1995-97  
ACCORD

98-072

## Recall: Accord Wire Harness Routing

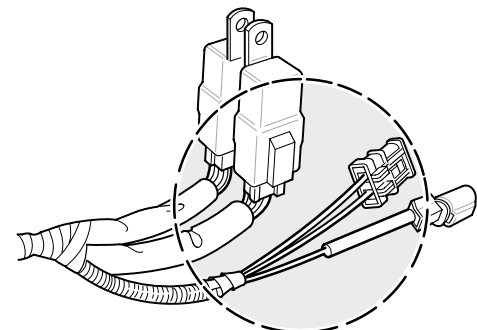
1. Remove the A/C compressor and condenser fan relays mounting nut.

2. Disconnect the condenser fan motor and the compressor clutch connectors.
3. Inspect the wires in the shaded areas as shown for damage to the insulation.
  - If any of the insulation has worn through so that the copper wire strands are showing, then go to REPAIR PROCEDURE A.
  - If there are no copper wire strands showing, even though there may be some damage to the insulation, go to REPAIR PROCEDURE B.

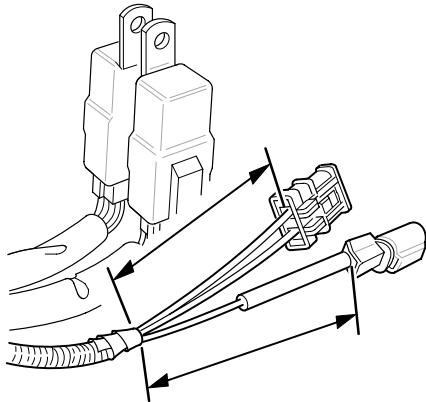
1. Measure the length of wire between the outer sheath and the connectors of the compressor clutch and the condenser fan motor.

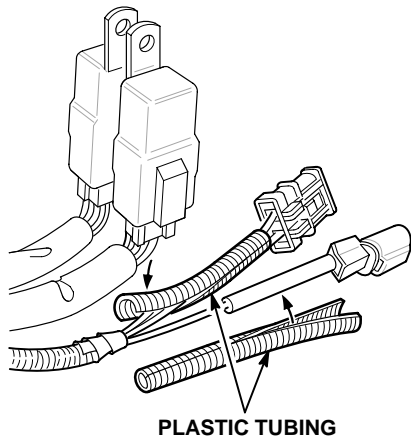
2. Cut two pieces of corrugated plastic tubing (see PARTS INFORMATION) to the lengths measured in step 1.
3. Install the tubing pieces over the wires.

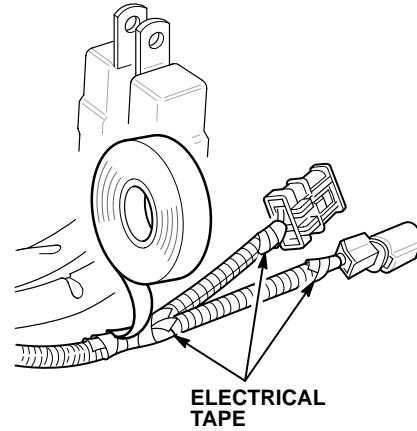
4. Anchor the tubes to the wire harness with 3M electrical tape (see REQUIRED MATERIALS).

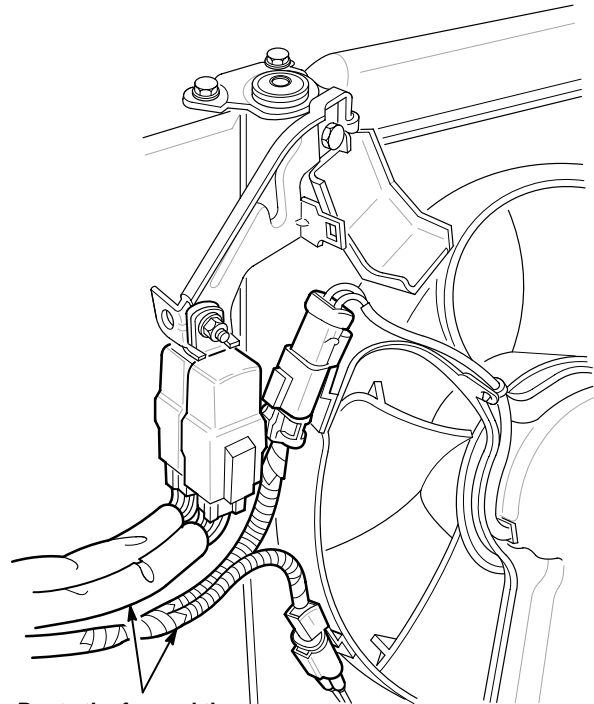
5. Reinstall the relays to the bracket with the original nut.
6. Route the wiring for the compressor clutch and the condenser fan motor, then reconnect the connectors.
